RE: Indiana Coal Council Comments on Duke IRP

ICC COMMENTS ON DEI IRP

The Indiana Coal Council (ICC) conducted a review of the Integrated Resource Plan (IRP) that Duke Energy Indiana (DEI) prepared and submitted to the Indiana Utility Regulatory Commission (IURC) on July 1, 2019.

Figure V.16: Capacity (contribution to peak MW) by year for the Moderate Transition portfolio

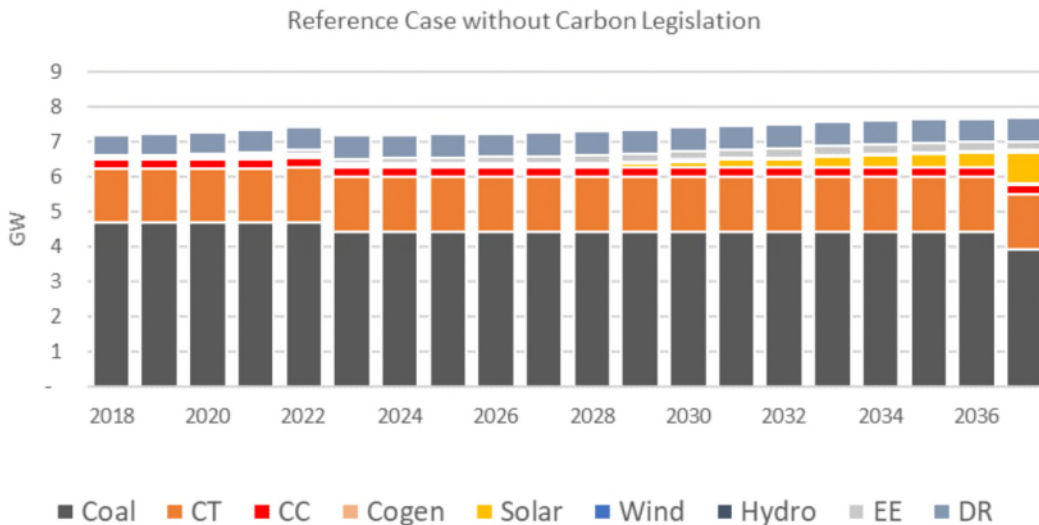
DEI assumes a significant carbon cost in the Moderate Transition Plan. As shown below, the resource plan without the assumed carbon cost, is materially different in that the only coal plant retirements found to be economic through 2036 are the two Gallagher units.
